KANSAS GAS AND ELECTRIC COMPANY

KMLNRC 81-129
Re: Docket No. STN 50-482
Ref: Letter dated 9/15/81 from BJYoungblood, NRC,
to GLKoeser
Subj: Geology

Question 231.5WC:

WOLF CREEK GENERATING STATION
UNIT NO. 1
 FINAL SAFETY ANALYSIS REPORT
FIGURE 231.5-1
BOUGUER GRAVITY MAP
OF EASTERN KANSAS

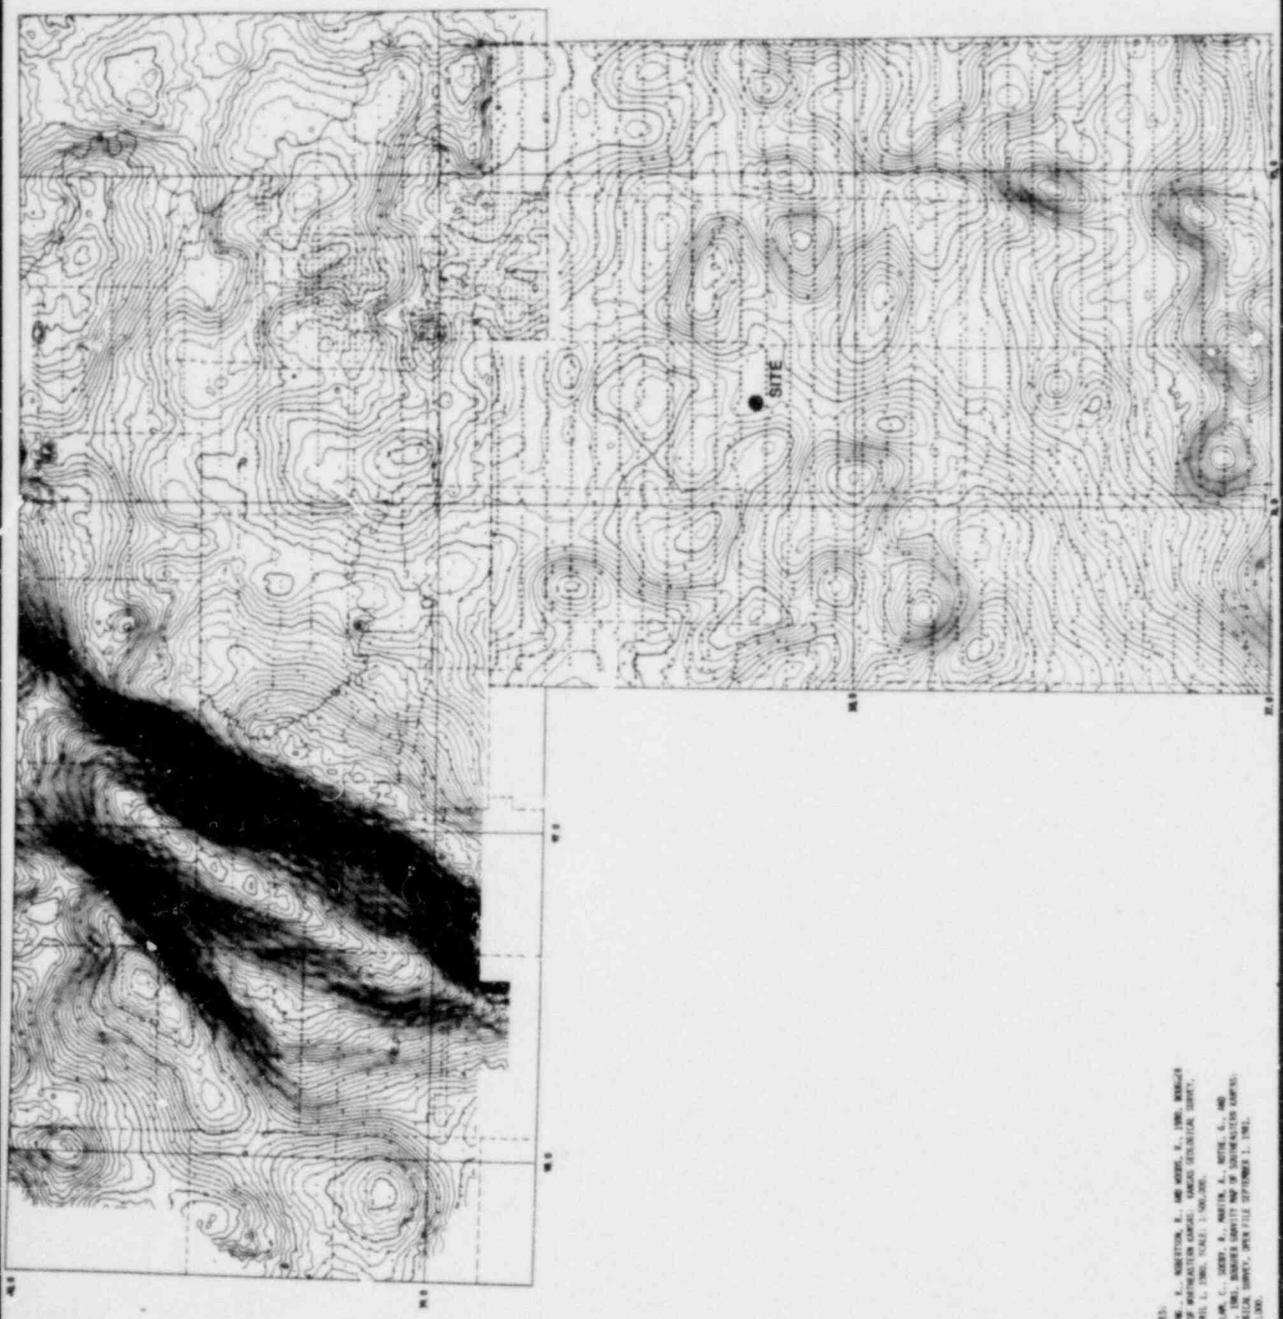
Discuss the following recent studies and their significance to the Wolf Creek site:

1. H. Yarger et al. 1981, Bouguer gravity map of Southeastern Kansas, Kansas Geological Survey, Open-File Report.
2. Steeples, D.W., 1981, Microearthquake network activities, Fiscal Year 1980, Kansas Geological Survey, Report to the Kansas City District Corps of Engineers.
3. Steeples, D.W., 1981, Structure of the Salina-Forest City interbasin boundary from seismic studies, Kansas Geological Survey, prepared for the W.H. McNutt Memorial Lecture Series.

The Bouguer gravity maps of northeastern and southeastern Kansas (Yarger & others, 1980; Yarger & others, 1981) were spliced together to produce the composite in Figure 231.5-1 (attached). The most striking feature on Figure 231.5-1 is the large, northeast trending, positive gravity anomaly located in the northwestern portion of the map. This positive gravity anomaly reflects mafic intrusives or lava flows related to the buried Central North American Rift System (CNARS) (See FSAR Section 2.5.1.1.5.1.17 and FSAR Figures 2.5-7 to 2.5-10). The flanking gravity lows reflect the presence of Precambrian clastic deposits associated with this ancient rift (See FSAR Section 2.5.1.1.5.1.17 and FSAR Figures 2.5-13 and 2.5-14; Steeples, 1981b).

A relatively steep north-trending gravity gradient located just east of $N40.0^{\circ}$ - $E96.0^{\circ}$ appears to be related to the Humboldt fault zone. The gradient curves toward the west about 20 km south of the Nebraska border. This curvature may reflect either a branch of the Humboldt fault zone or an indirect relationship between the gravity gradient and fault zone (Steeple, 1981b). The origin of the gravity low in the Forest City Basin (northeastern part of Figure 231.5-1) is not known (Steeple, 1981b).

A comparison between aeromagnetic and gravity anomaly maps (FSAR Figure 2.5-9 and Figure 231.5-1 shows that, in general, the circular positive aeromagnetic anomalies in the Forest City Basin are not associated with positive gravity anomalies. The origin of these aeromagnetic anomalies (younger Precambrian granites intruded into older Precambrian granite terrane) has been discussed elsewhere and accounts for the absence of corresponding positive gravity anomalies (FSAR Section 2.5.1.1.5.J.17; Response to Question 230.4WC).

An almost circular gravity low (-65 to -67 mgal) in Osage County, approximately 15 miles due north of the site corresponds with a circular positive aeromagnetic anomaly (1000 to 2000). The coincidence of a magnetic high and gravity low may indicate that the underlying crust contains an intrusion different in composition from the Miami and Douglas County Precambrian granites (Steeple & Bickford, 1981).

A gravity low at approximately $37^{\circ}42'N$, $96^{\circ}26'W$ lies within the Wichita aeromagnetic low (Figure 231.5-1; Response to NRC Question 230.4WC; Yarger, 1981a). The shapes of these lows are not coincident and the origin of the Wichita low is not known.

An area of relatively high Bouguer gravity values is located in extreme southeastern Kansas (Figure 231.5-1). This gravity high encompasses an area containing isolated positive aeromagnetic highs. The region of high gravity values may represent Precambrian felsic volcanic terrane whereas coincidence with aeromagnetic highs may reflect undiscovered mafic intrusions (Bickford & others, 1979).

It is interesting to note that contour trends visible on the 1964 Bouguer gravity map of the United States (FSAR Figure 2.5-8) have been defined in greater detail on Figure 231.5-1. This observation can be corroborated by following the -60 mgal contour at the site on FSAR Figure 2.5-8 and comparing it with the -60 mgal contour on figure 231.5-1. This comparison indicates that the major northeast

The Bouguer gravity map of southeastern Kansas shows that there are no closely spaced contours indicating sharp gravity gradients in Coffey County (Yarger & others, 1981). Detailed analysis of the Bouguer gravity map, other geophysical data and subsurface data will add to our knowledge of crust and mantle structure beneath eastern Kansas. On the basis of these data, there are no indications of crustal features that may represent a hazard to site safety.
